UNITED STATES
NUCLEAR REGULATORY COMMISSION
WASHINGTON, D.C. 20555-0001

FACILITY: Salem Nuclear Generating Station, Unit Nos. 1 and 2

SUBJECT: SUMMARY OF MARCH 16, 2010, MEETING WITH PSEG NUCLEAR LLC, REGARDING RESPONSE TO GENERIC LETTER 2004-02 FOR SALEM NUCLEAR GENERATING STATION, UNIT NOS. 1 AND 2 (TAC NOS. MC4712 AND MC4713)

Figure 1: Side View of Flume

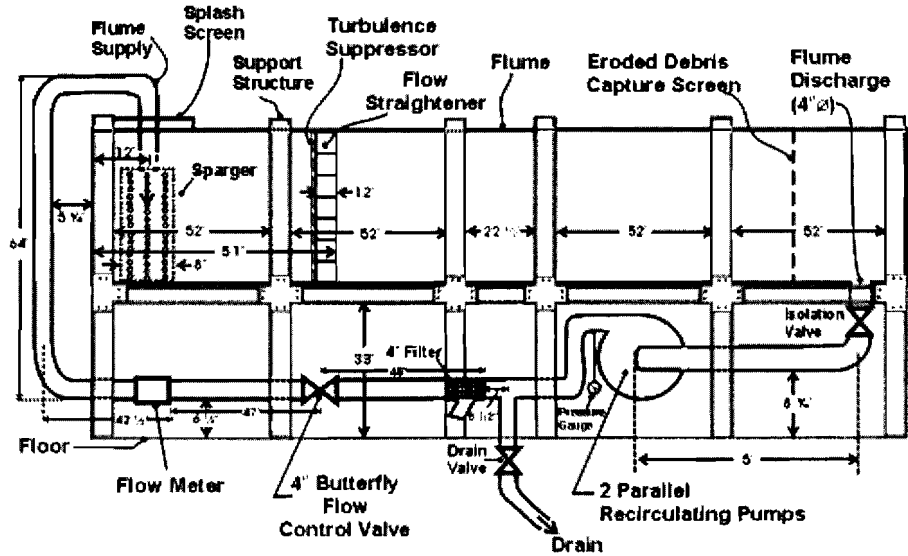
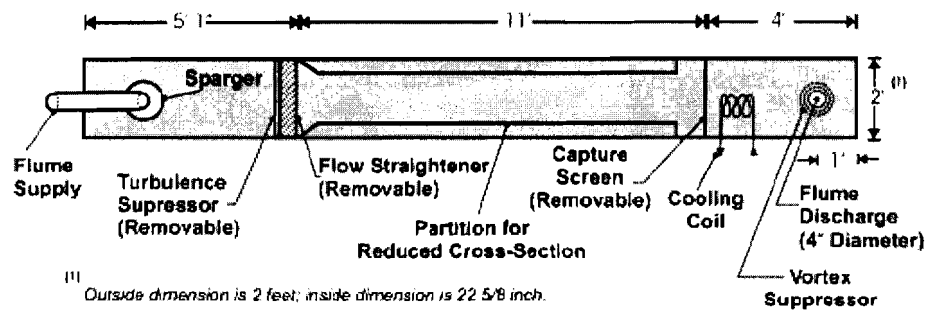
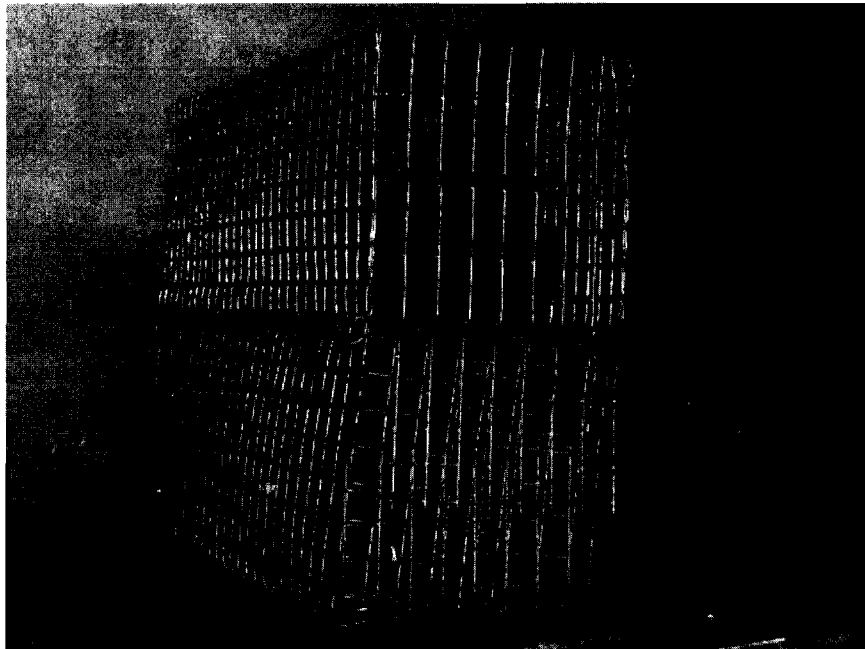
During the staff's audit of strainer performance calculations in October 2007, cumulative 30-day erosion percentages of 40% for Nukon and 15% for Kaowool® refractory fiber insulation were assumed to address NRC staff concerns associated with the erosion test results for Nukon and Kaowool. However, the March 31, 2009, supplemental response indicates that the currently assumed 30-day erosion percentages are 30% for Nukon and 10% for Kaowool. A basis was not provided in the supplemental response to justify the reduced erosion percentages that are currently assumed. Please provide a technical basis for the currently assumed 30-day erosion percentages for Nukon and Kaowool to address the concerns identified with the testing in the audit report and demonstrate that the percentages are prototypical or conservative for the plant condition.

PSEG performed testing at Fauske and Associates Incorporated (FAI) to estimate the extent of the erosion of large and small pieces of Nukon and Kaowool fibrous debris in a 30-day period in the Salem containment pool. The NRC staff reviewed the erosion testing method, results, data analysis and conclusions during the detailed audit of the Salem Unit 1 and Unit 2 sump strainer design (Reference 10). A short description of the erosion testing performed is provided below followed by a discussion of the data analysis.

The erosion testing was performed for the two primary types of fiber insulation present at Salem: Nukon and Kaowool. For each test, samples of each type of insulation were placed in stacked wire mesh baskets in a flume. The insulation samples were scissor cut rectangular pieces between 1/4 inch and 4 inches in size and were baked prior to the erosion tests to simulate exposure to hot surfaces in containment.

The baskets extended across the entire width of the flume and were installed downstream of the flow straightener. Two stacked baskets were used simultaneously to restrain the debris samples during the erosion testing. The Nukon fiber samples and Kaowool fiber samples were distributed between the two baskets such that the samples only occupied a fraction of the total basket volume and each piece of fiber was directly exposed to the flowing water. Initially, when all the fiber samples were placed in the two baskets the volume occupied by the fiber samples was between approximately 9 and 13 per cent of the total basket volume. As fiber samples were removed to be dried and weighed, the volume occupied by the debris in the two baskets continually decreased. A turbulence suppressor and flow straightener were located upstream of the fiber samples.

Figures showing the flume and wire mesh baskets are provided below. Note, the capture screen shown in Figures 1 and 2 was not used. These figures also do not show the wire mesh baskets which were used.

Figure 1: Screen Shot from Vortex Test Video

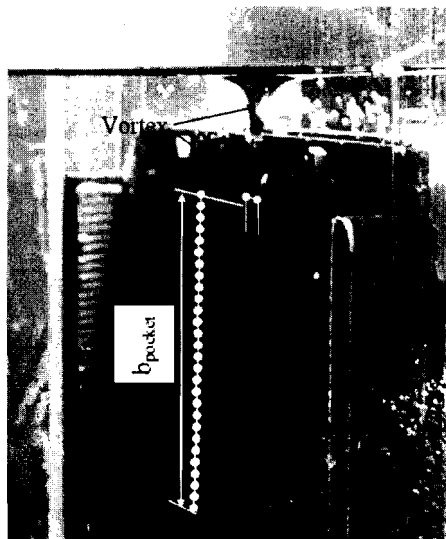
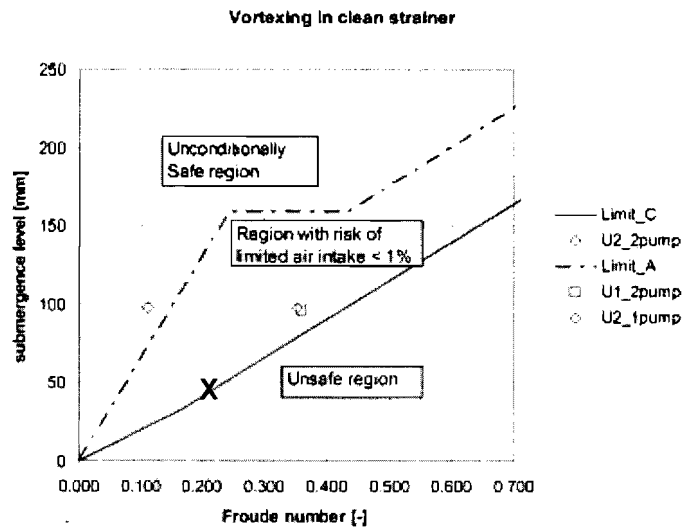
The supplemental response stated that there is a potential for intermittent vortex formations during two pump operation at the minimum submergence level with little or no debris on the strainer. The March 31, 2009, submittal stated that video analysis of the test showed that the maximum air ingestion rate during the test was 0.05% by volume. The response further calculated that the total air entrainment would be 0.00356% if the entire strainer train was included in the calculation. The staff needs more information regarding the video analysis and the calculation to determine whether the methodology used to derive the estimate is realistic. It is not clear how video could be used to estimate the amount of entrained air.

The video was used to determine the size of potential vortices which could occur for the clean screen condition. The size of the vortex relative to the pocket was estimated based on the image below. Figure 1 below is an image that was taken from a video of a clean screen vortex test whose Froude number (0.218) and submergence (1.8 in) bound the worst case Froude number and submergence (3.8 inches) at modules nearest the sump pit at Salem. The minimum submergence at Salem is based on the minimum water level at switchover of 80'-10", which includes 0.25 inches of margin. The water level then increases from the minimum to over 81'-6" for the conservative case of a LOCA with full RCS reflood. The water level following switchover is computed using the conservative assumptions outlined in §3g.8 of Attachment 1 to the March 2009 Supplemental Response.

The CCI Generic Vortex Tests were used to develop Figure 3f.3.1.1-2 in the March 2009 Supplemental Response, repeated as Figure 2 below. Figure 2 shows strainer operating regions with respect to vortex formation based on strainer submergence level and Froude number. The data point selected for the vortex analysis (explained below) is marked as a black 'X' on the red "Limit_C" line used to delineate the unsafe operating region from the operating region with limited air intake. Salem operates in the safe region with limited air intake, as shown by the U1_2pump, U2_1pump, and U2_2pump data points in Figure 2. Vortices such as the one shown occurred less than 20% of the time, but are conservatively assumed to occur 100% of the time in the vortex analysis.

Based on scaling of the screen shot in Figure 1, the vortex diameter is approximately $1/27^{\text{th}}$ of the height of the pocket. Since the pocket opening is 120 mm tall, the diameter of the vortex is 4.44 mm [=120 mm/27], and the cross sectional area of the vortex is $1.55 \times 10^{-5} \text{ m}^2$ [= $\pi d^2/4$].

Figure A- 25 Streamlines and vector plot (9000 gpm transient)

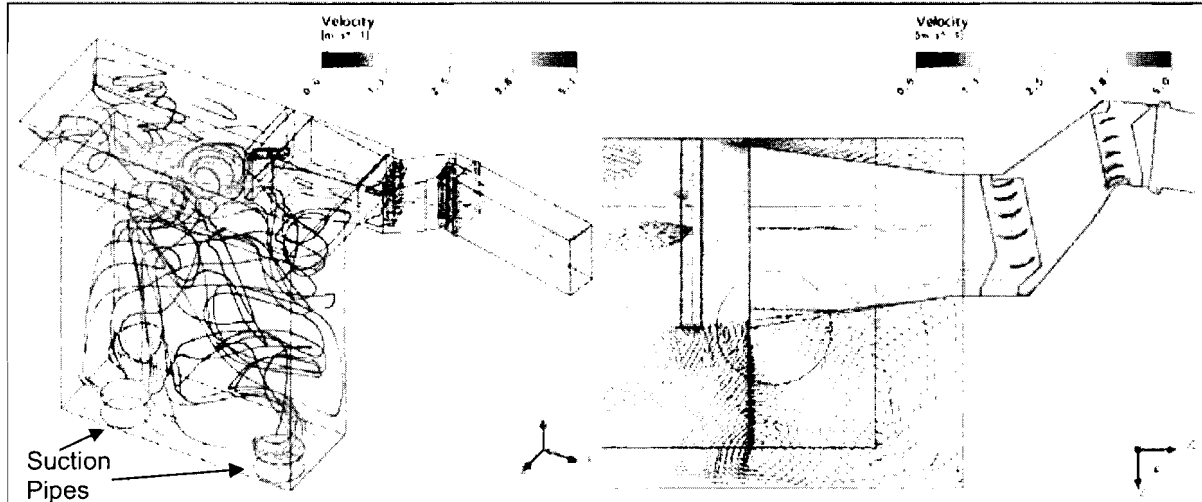
In its March 31, 2009, submittal, the licensee provided a calculation of void fraction due to vortexing and degasification of the fluid as it passes through the debris bed. Staff evaluation of the response is split into two sections. Further information is required for both the vortex formation and degasification areas.

The ability of air bubbles to accumulate at the top of the suction box is addressed using streamlines produced as part of the CFD analysis of the suction box created for the strainer head loss computation. Based on the streamlines shown in Figure A-25 below, there is a clear movement of water entering the sump pit from the diffuser of the z-shaped duct to the ECCS pump suction pipes, with velocities in the top region of the pit of 1 m/s or more. The streamline plots show the primary flow of water from the diffuser moving towards the rear wall of the pit and then down towards the pump suction pipes.

The CFD analyses also determined that the average velocity across both a horizontal plane near the top of the sump (not in the suction box) and a horizontal plane near the bottom of the sump (near the outlet pipes) is ~0.3 m/s for a 5110 gpm flow and ~0.5 m/s for a 9000 gpm flow. These velocities are much greater than the maximum upward velocity for air bubbles evolved in the debris bed.
